Docket No. 50-346  
License No. NPF-3  
Serial No. 1-1067  
August 14, 1984  
Page 2

## SAFETY EVALUATION

This Safety Evaluation is written to justify that adequate cooling capacity exists for the Emergency Core Cooling System (ECCS) pump room, decay heat cooler from and H<sub>2</sub> dilution system blowers with the valves SW-86, SW-94, SW-102, SW-108, SW-116, SW-371 and SW-381 locked closed (see Fig. 9.1.-1 attached).

FIG. 1

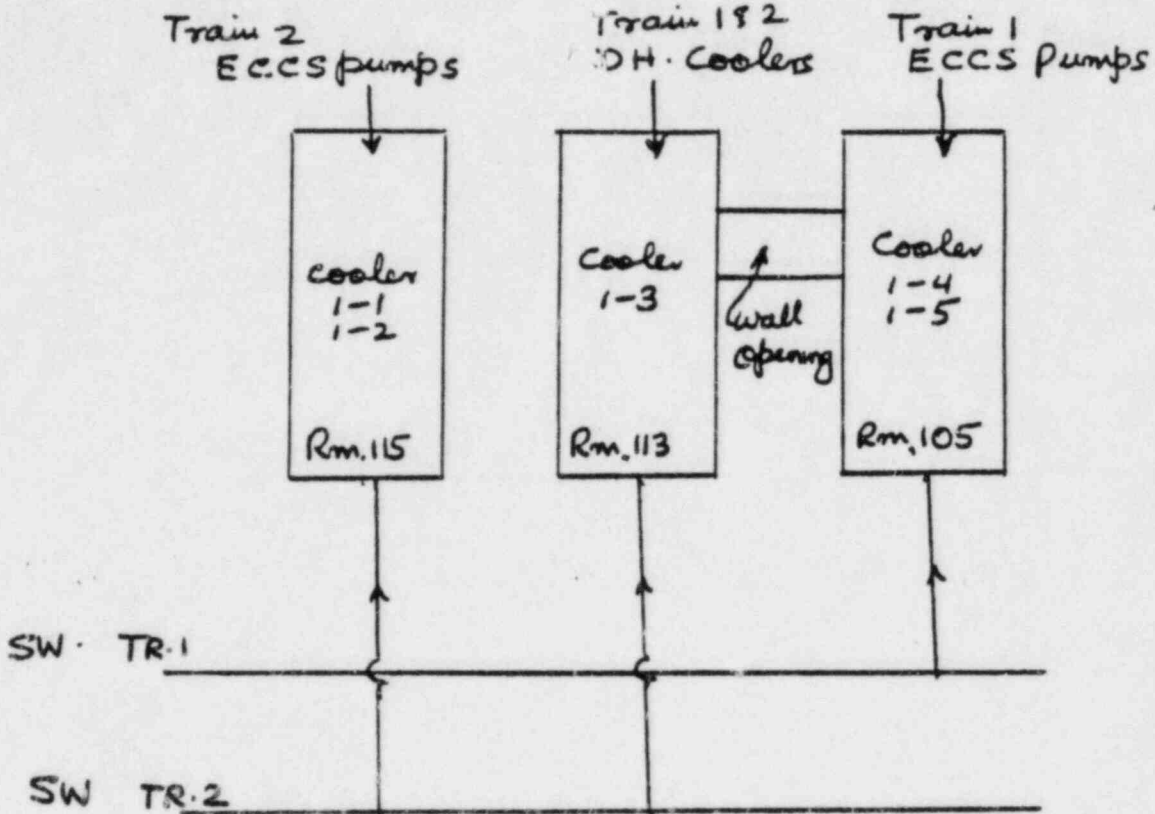
ECCS pump room coolers 1-1 and 1-2 are located in room 115 (ECCS pump room 2), coolers 1-4 and 1-5 are in room 105 (ECCS pump room 1) and the cooler 1-3 is located in room 113 (DH cooler room) (see Fig. 1 attached). There are at present two trains of service water that supply water to each of the above coolers. However, only one train of service water is required to serve each of these coolers.

If train 1 of service water which provides flow to ECCS pump room coolers 1-4 and 1-5 in room 105 fails, the redundant train 2 will provide flow to the ECCS pump room coolers 1-1 and 1-2 in room 115 and the decay heat cooler room cooler 1-3 in room 113. The operable train 2 of SW will provide adequate cooling capacity in ECCS pump room 115 and decay heat cooler room 113, and, as a result, train 2 ECCS pumps will remain operable.

If train 2 of service water which provides flow to the ECCS pump room coolers 1-1 and 1-2 in room 115 and decay heat cooler 1-3 in room 113 fails, the redundant train 1 will provide flow to ECCS pump room coolers 1-4 and 1-5 in room 105. We have calculated that two coolers in ECCS pump room 105 will have adequate capacity to remove the heat loads in rooms 105 and 113, and will maintain these room design temperatures equal to or less than 122°F in accident condition. Therefore, the operable train 1 of SW will provide adequate cooling capacity in ECCS pump room 105 and decay heat cooler room 113, and, as a result, train 1 ECCS pumps will remain operable.

Pursuant to the above it is concluded that changing the valves' position in the proposed change from locked open to locked close and eliminating the requirements for reverse flow testing of the associated check valves will not degrade the SW system's redundancy to meet the single failure criteria, and the two SW trains will be properly isolated from each other. As a result, there is no unreviewed safety question involved.
